From: [Wolfenbarger, Jeanne](#)
To: ["Vinny Perea"](#)
Subject: Freddy's (Formerly Whataburger)
Date: Monday, June 01, 2015 4:37:00 PM

RE: **Whataburger
Grading Plan
Engineer's Stamp Date 2-18-2015 (File: K10-D001B)**

**RE: FREDDY'S (PREVIOUSLY WHATABURGER), 111 COORS BLVD. NW
GRADING AND DRAINAGE PLAN
ENGINEER'S STAMP DATE 2-18-2015 (K10-D001B)**

**FREDDY'S AT
COORS AND CENTRAL
GRADING AND
DRAINAGE PLAN**

STORMCHAMBER® TYPICAL CROSS-SECTION INSTALLATION

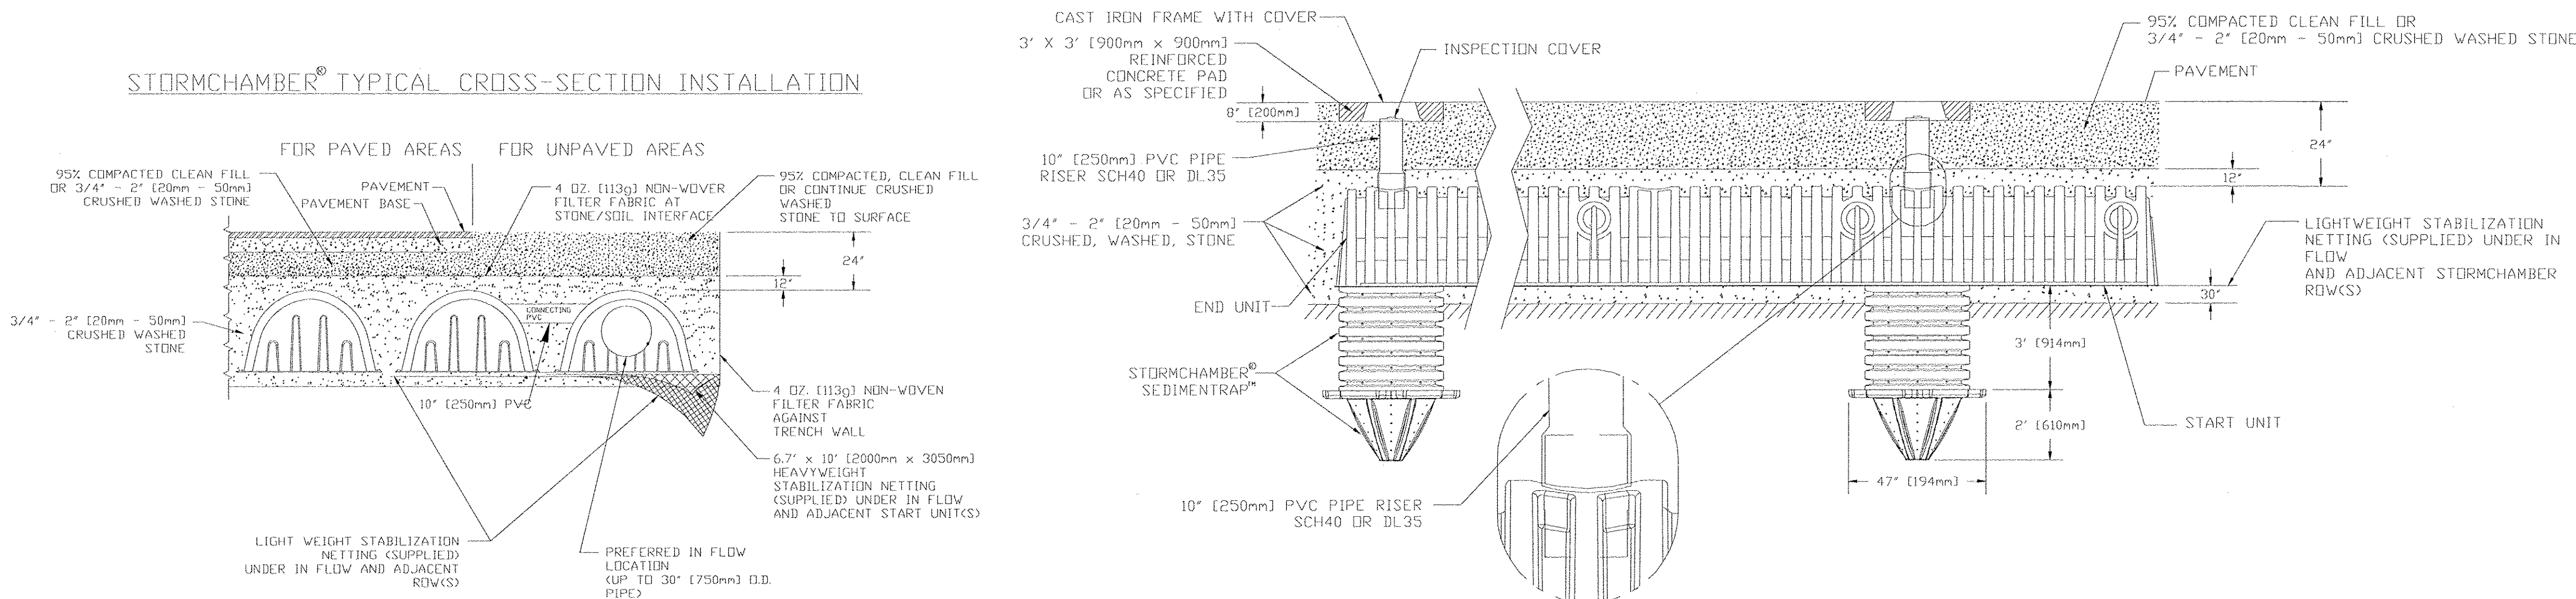
- 9) The number of chambers shown on the "Basin Map and Calculations" sheet is 75. This needs to be called out on the plan view detail on the "Stormchamber Storage System" sheet to make sure the right number of stormchambers will be installed. Also, please provide a legible table showing the layout dimensions for the stormchambers.

9. The number of chambers shown on the "Basin Map and Calculations" sheet is 75. This needs to be called out on the plan view detail on the "Stormchamber Storage System" sheet to make sure right number of stormchambers will be installed. Also, please provide a legible table showing the dimensions for the stormchambers.

Response: The number of chambers was reduced from 75 to 69. This was modified in the Stormchamber volume calculations and is called out on the plan view detail on the "Stormchamber Storage System" sheet. The table showing the material quantities and the cross sections of the chambers was modified to be more legible.
